MEMORANDUM

DATE: January 4, 2002
TO: Montgomery County Planning Board
VIA: Joe R. Davis, Chief
Development Review Division
FROM: Larry Ponsford AIA AICP
Planning Department Staff
(301) 495-4576

REVIEW TYPE: Site Plan Review
APPLYING FOR: Approval of 69 single-family dwellings on 32.6 acres, including 9 MPDU's
PROJECT NAME: Westphal/Blalock Property
CASE #: 8-02015
REVIEW BASIS: Sec. 59-D-3, M. C. Zoning Ordinance

PROJECT DESCRIPTION: Proposal

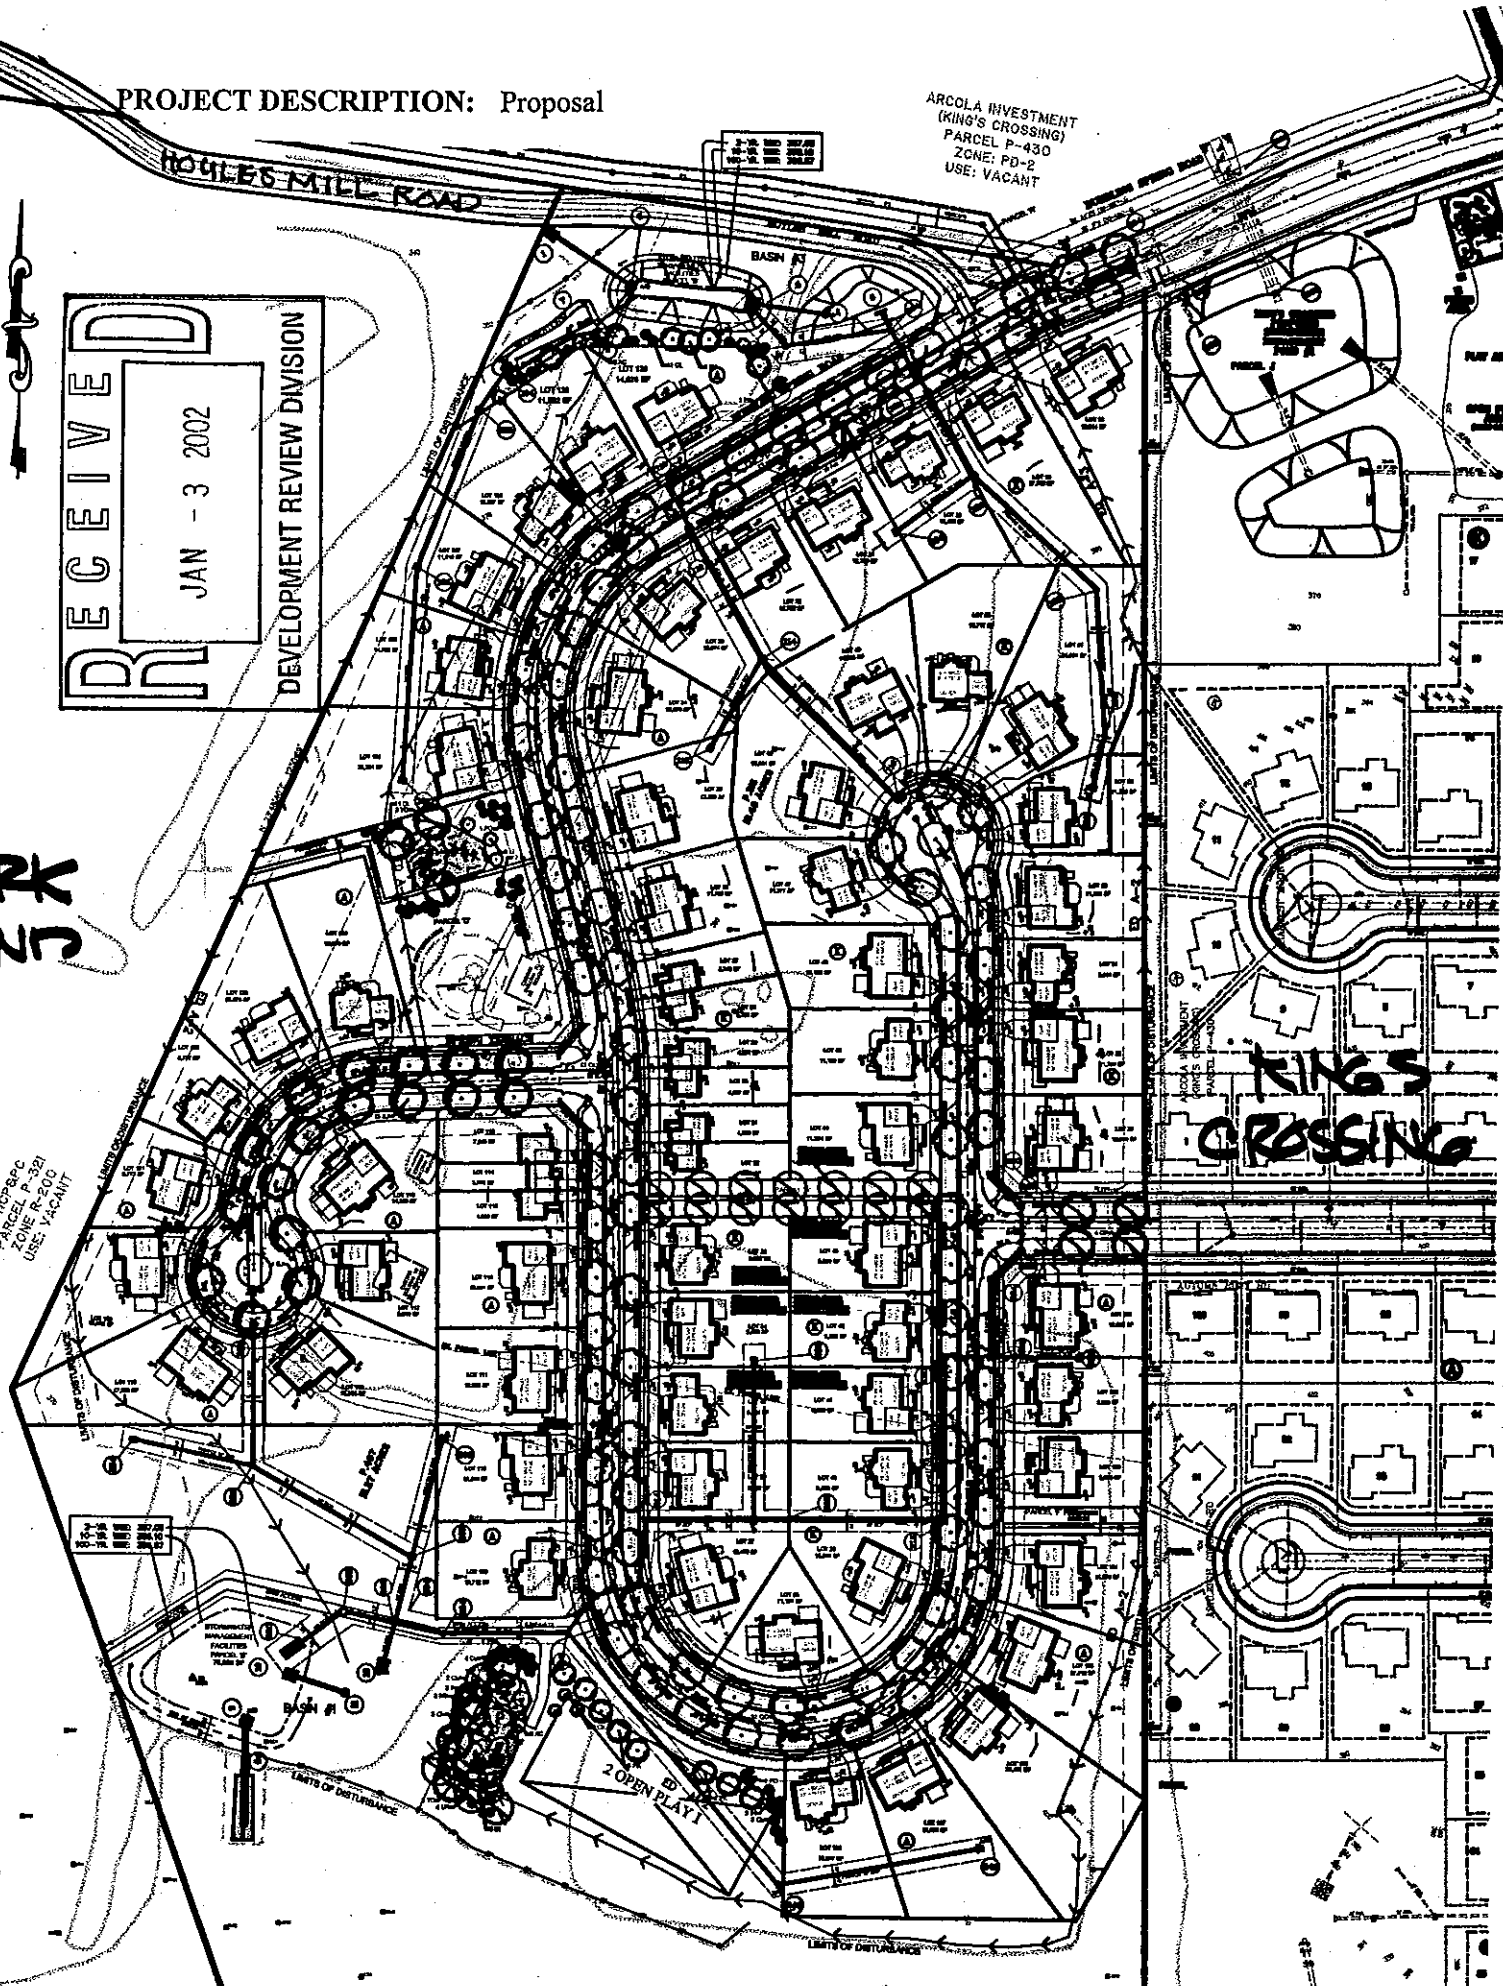
10. Provide note on plats which will preclude widening of driveways by subsequent homeowners
11. Swap locations of multi-age play area and lot 7, regrade parcel C to blend with new play area site, provide new path eastward off-site on a 25-ft easement on an HOA parcel adjacent to relocated lot 7

12. Provide tree protection for the specimen tree on parcel C to correspond to August 13 memo on this subject from Development Review Division Enforcement personnel

13. Place landscaped islands in culs-de sacs
14. Significantly increase landscaping at SWM pond on parcel B, per MCDPS guidelines
15. Re-position street trees at 50-foot intervals; integrate pattern of street lighting with this interval

16. Introduce screen planting along Kings Crossing boundary property line
17. Introduce a landscape screen along the rear property line of the MPDUs
18. Set up a design framework for landscaping between the SFD's rear yards
